## COPPERBERRY CONDOMINIUM

RETAINING WALL DESIGN FOR NORTH BUILDING

SHEET NO. C2.0

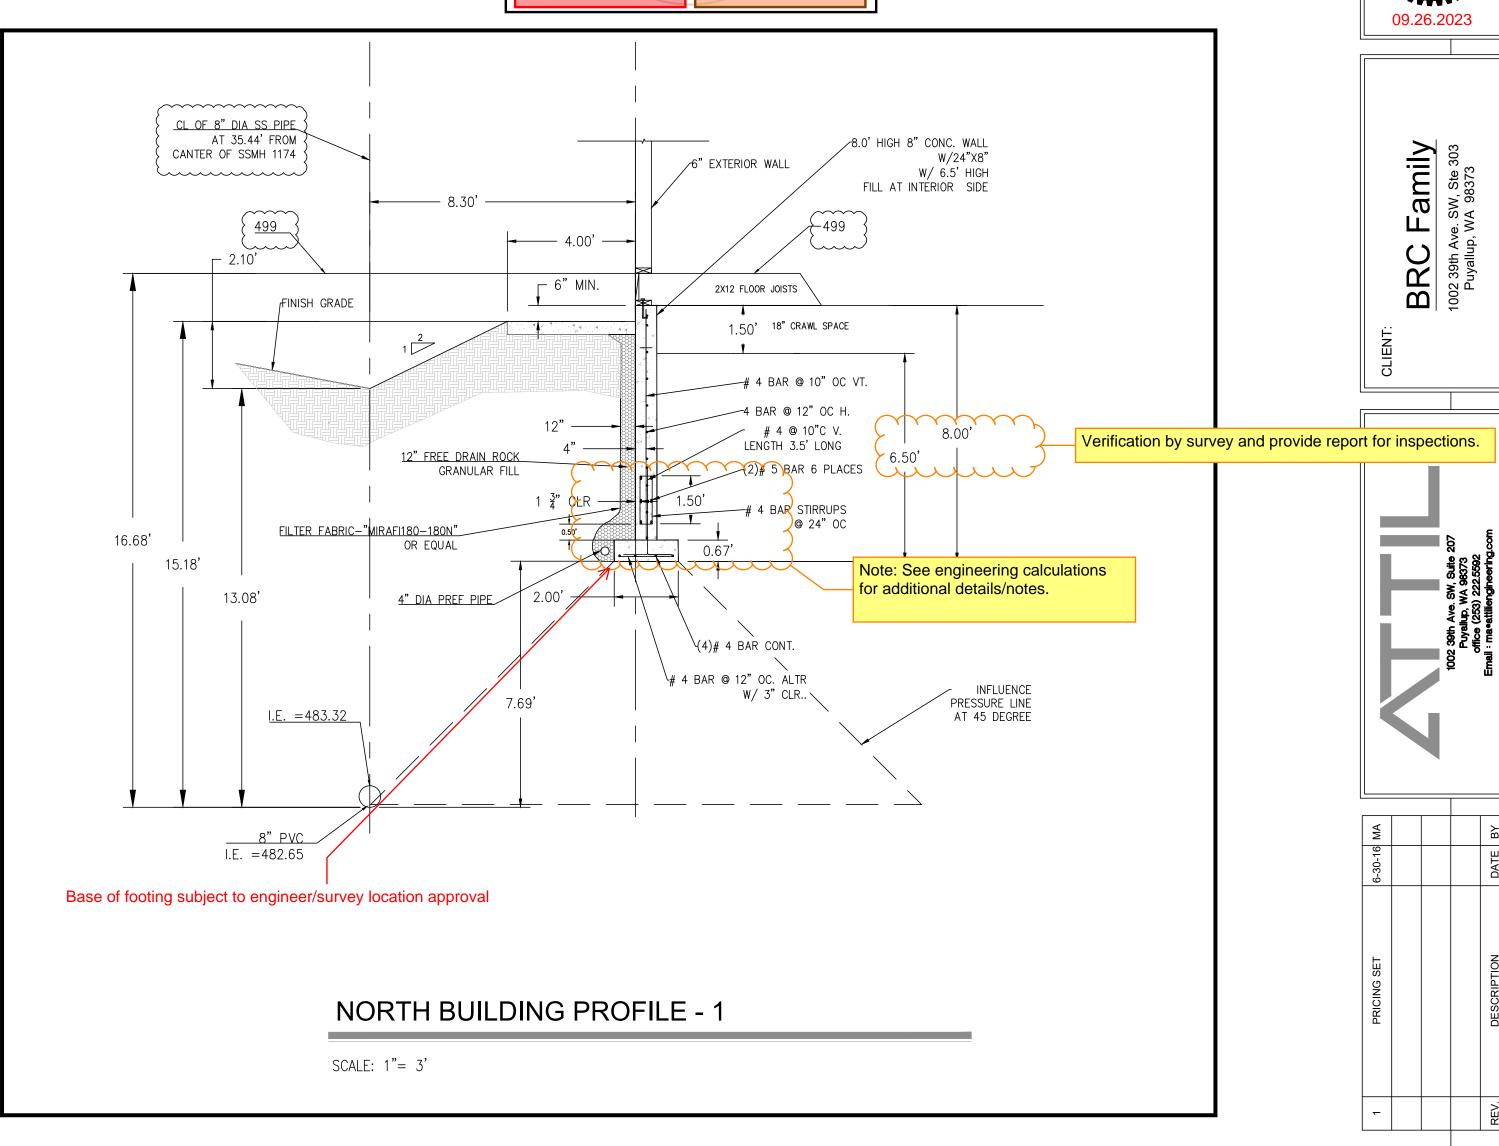
The approval of this drawing is for the area of influence of the foundation to the existing sewer main that is west of the proposed building. It is has not been reviewed for the construction of the retaining wall. See sheet C2.0 2

Revision and engineering verification of clearance from the angle of influence, identified by the engineer.

Subject to inspection and field reports required by review comments.
